Georgia Department of Natural Resources

Re: Corps ACF Operations Under the IOP

To: Carol Couch
From: Wei Zeng
Date: April 5, 2007
Re: IOP Concept 5 operation for the rest of year 2007

Fig. 15 Comparison of projected and observed (in 2000 through 2001) Jim Woodruff elevations

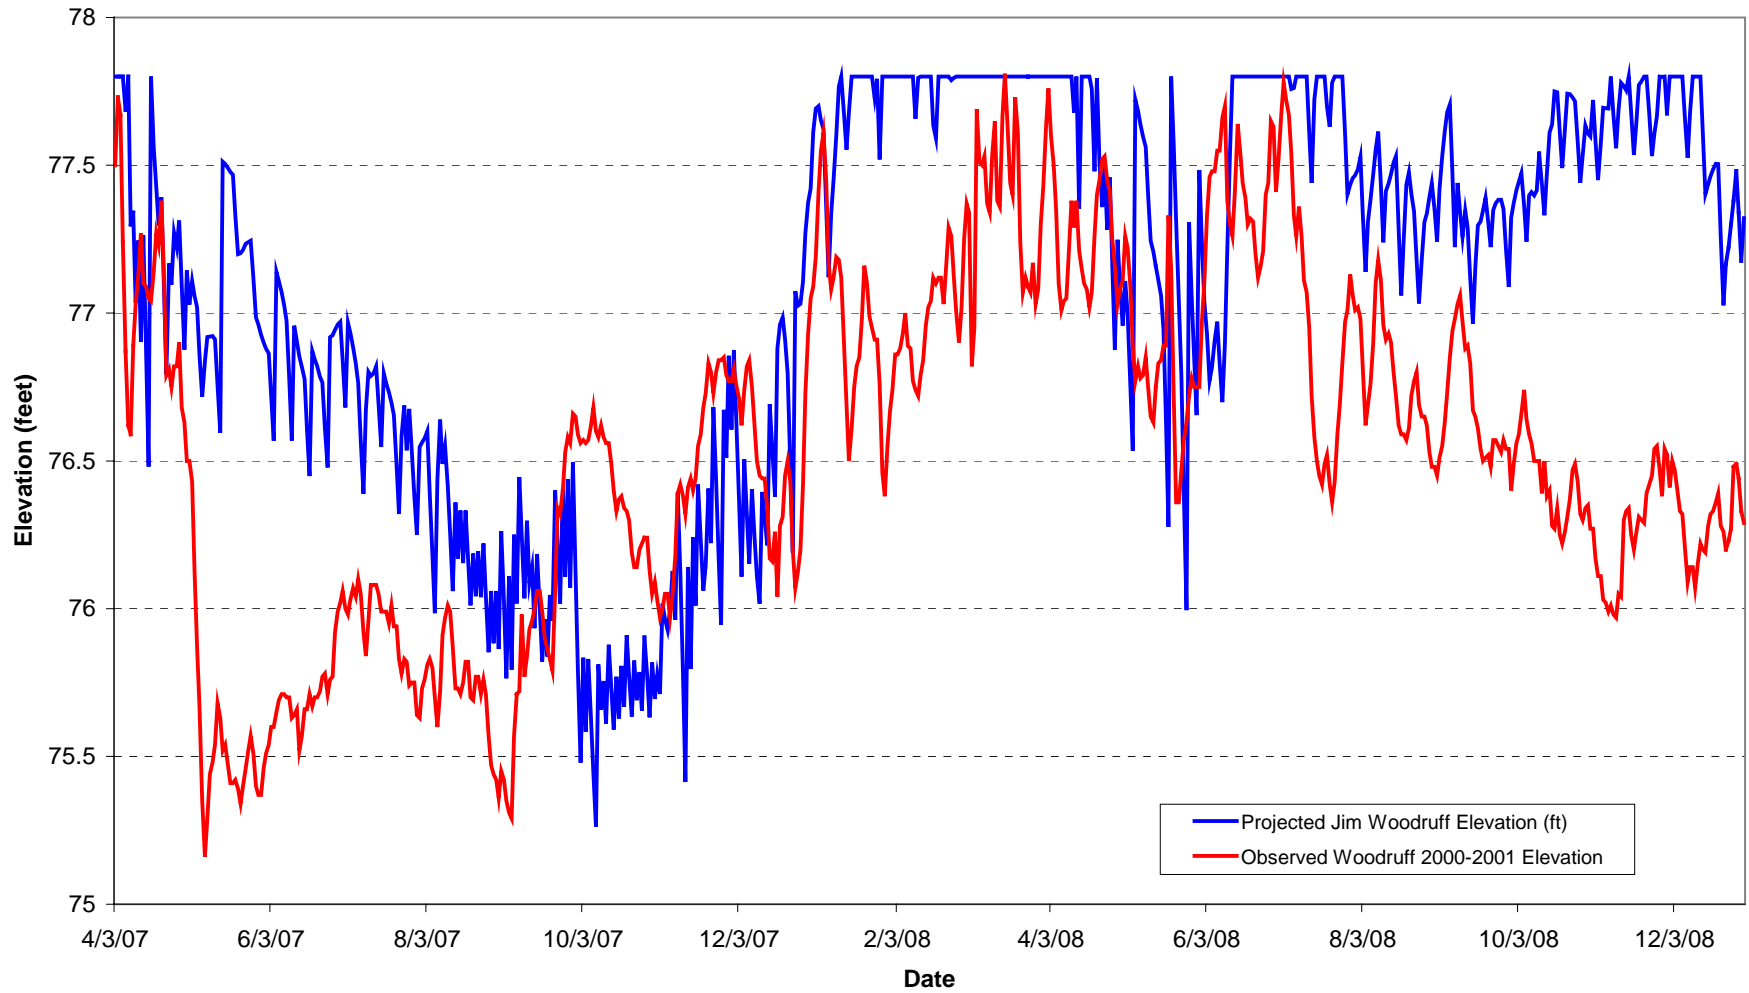
Jim Woodruff is relatively small compared to Lanier, West Point, and Walter F. George, and it is heavily influenced by the operations of these storage reservoirs. However, the storage deficit at Jim Woodruff depicted in Fig. 14, together with similar storage deficits at all the upstream reservoirs, clearly shows a system under enormous stress from high releases and the lack of refilling, a feature that been the hallmark of all versions of the IOP, including Concept 5 (Fig. 15).

Fig. 16 Simulated Jim Woodruff release and minimum flow requirement under IOP Concept 5

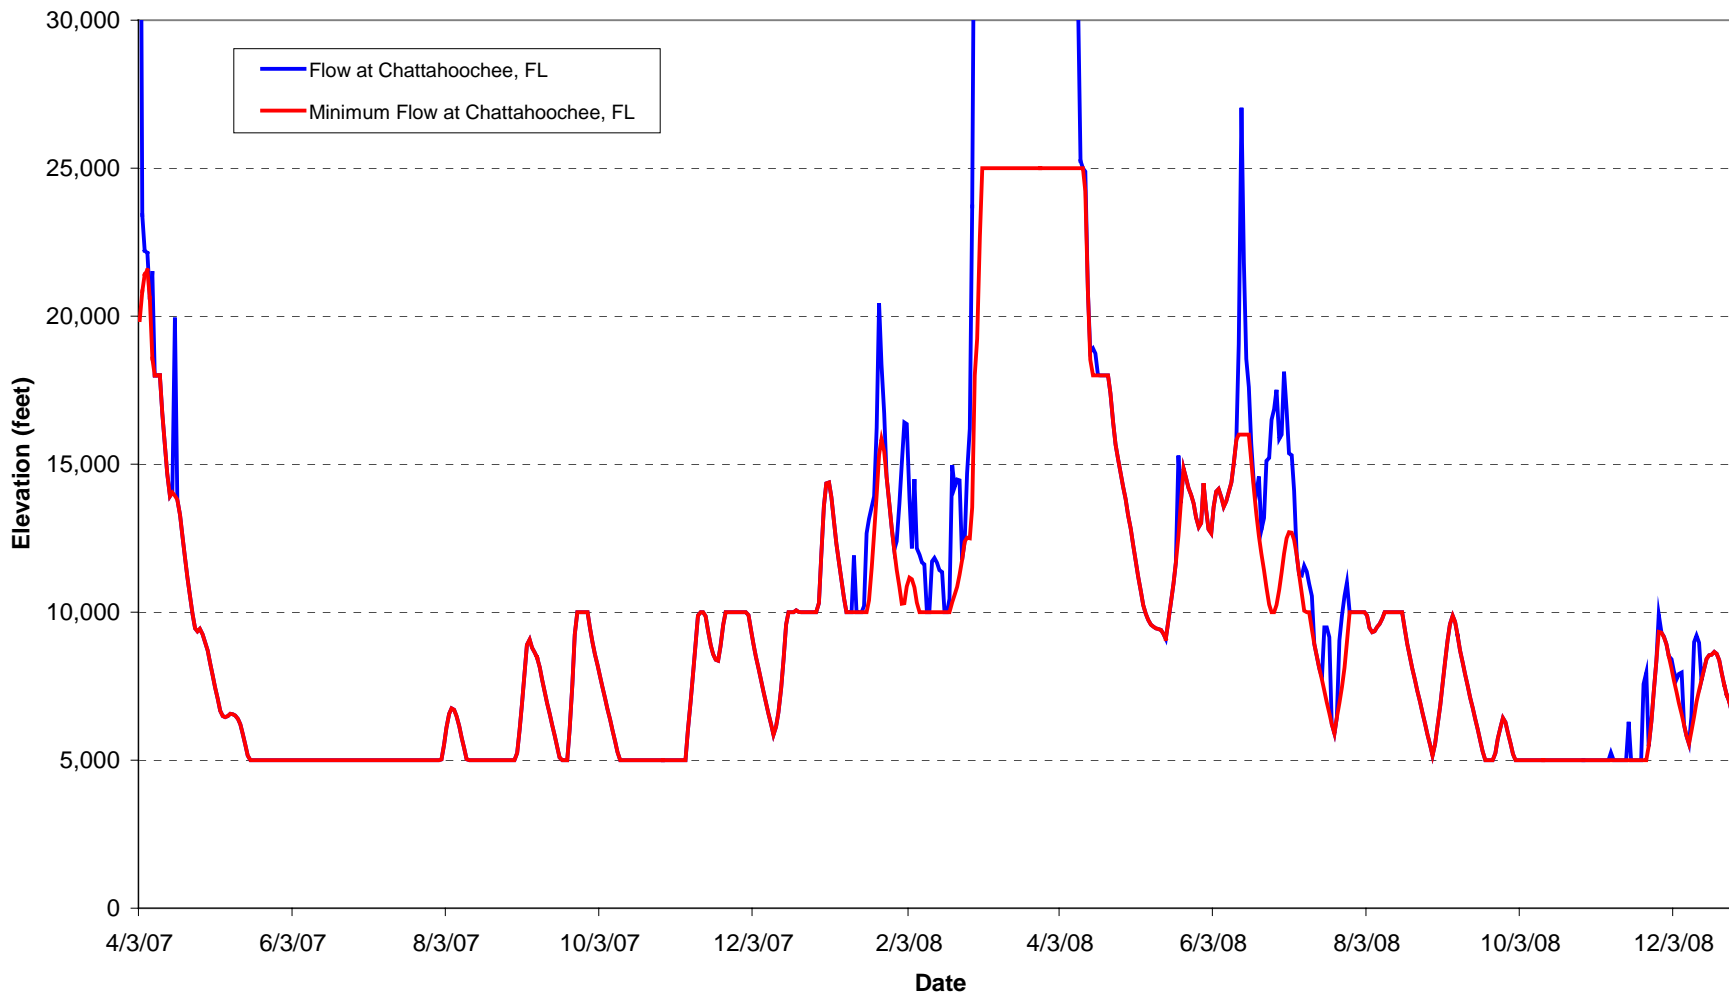
Our model (and any models without an explicit expression of over-release) does not assume the release from Jim Woodruff to be any higher than the flow requirements, as long as the reservoir elevations fall in the ranges of their respective conservation pools. This is reflected by the fact that simulated Jim Woodruff release closely follows minimum flow requirements prescribed by the IOP Concept 5 (Fig. 16).
